## FORK LOCK ADJUSTING SCREW / 1980 FLT MOTORCYCLES

Figure 2. Position of Adjusting Screw Assembly

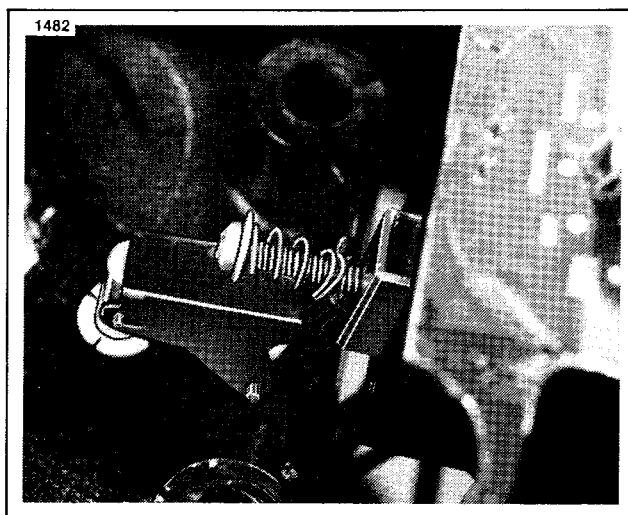
3. Remove locknuts that secure lower handlebar clamps. These are located under the instrument housing. Be very careful not to scratch the paint on the gas tank while removing.
4. With the locknuts removed, lift handlebar assembly up and out.
5. Remove the ignition switch tamper shield. Examine switch for Code 048 recall. (See Service Bulletin M-770.) Perform if required.
6. Remove fork lock adjusting screw, spring, and washer (see Figure 2).
7. Reinstall new fork lock adjusting screw and locknut, from 93335 Kit, along with spring and washer from original assembly. Turn it a few turns

Figure 3. Proper Tool Location

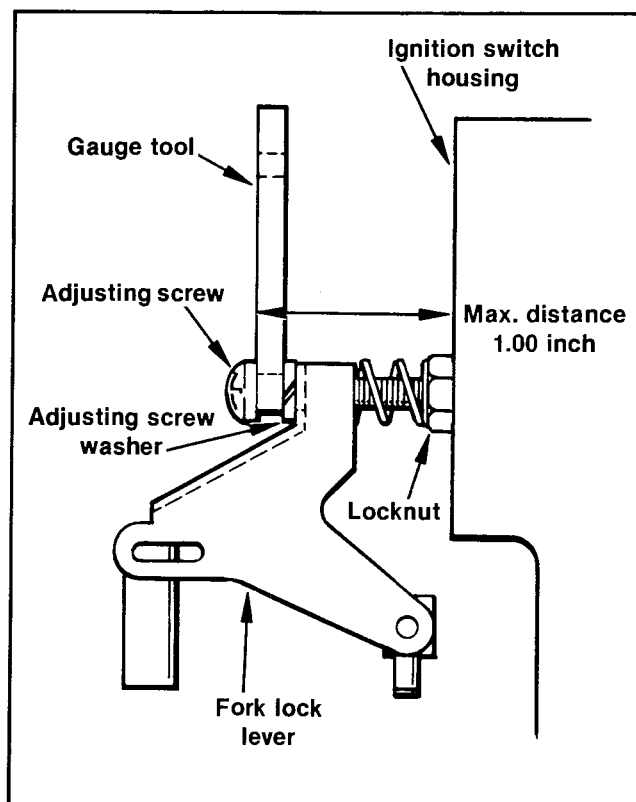
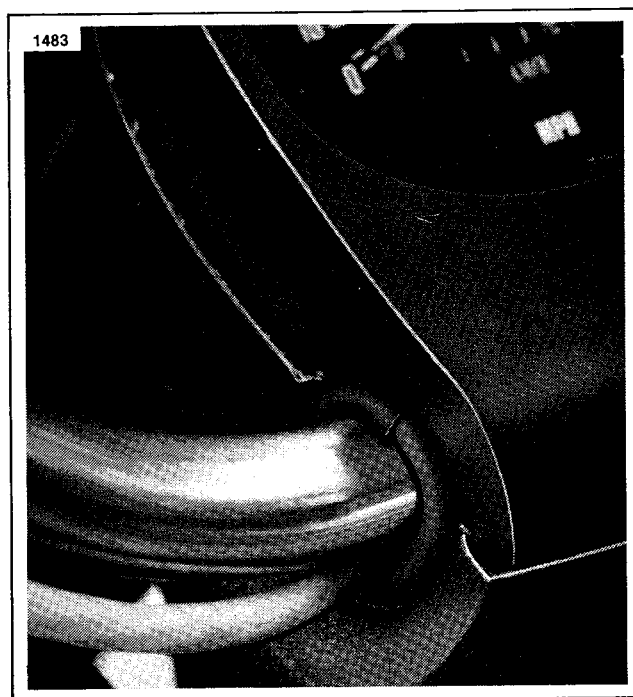
8. Adjust mechanism as follows:
  - A. Position instrument mounting housing and wheel straight ahead.
  - B. Turn ignition switch to fork lock position.
  - C. Push the front fork lock lever assembly down until lock pin rests on the frame plate.
  - D. Insert special gauge tool, from Code 048 Kit 93330, between the adjusting screw head and washer so slot in gauge rests on the screw shaft (see Figure 3).

*The gauge tool is the recommended method for properly spacing the adjusting screw because the gauge rests on the screw shaft and prevents mispositioning the screw while tightening. The same spacing can be produced by placing two EQUAL Pieces of metal — thickness .160 to .170 inch — on either side of the adjusting screw between the screw head and washer.*

- E. Tighten screw until adjusting screw, washer and gauge touch lever.
  - F. Measure distance between screw head and fork lock assembly. This distance should not exceed 1.00 in.

- G. When correct distance and alignment is achieved, apply Harley-Davidson Stud 'n Bearing Mount, Part No. 99626-77, to inner threads of adjusting screw and tighten locknut over Stud 'n Bearing Mount against the fork lock housing.
